Peoria Park District
Bradley Park Equipment Service Center
1314 N. Park Road
Peoria, IL 61604
Telephone: (309) 686-3386

ADDENDUM NO. ONE

PROJECT TITLE: Charter Oak South Dam Repair

ISSUANCE DATE: June 19, 2013

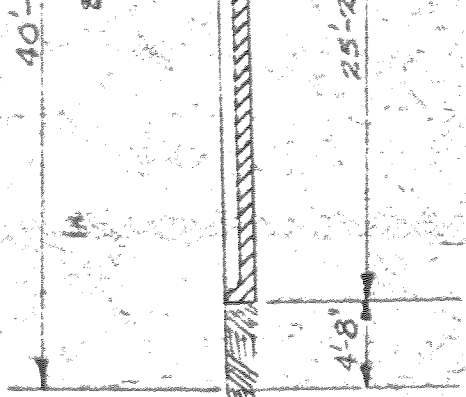
Clarification: The engineer's report states that the gap between the pipe sections, is 5", not the 12" that was stated at the pre-bid meeting.
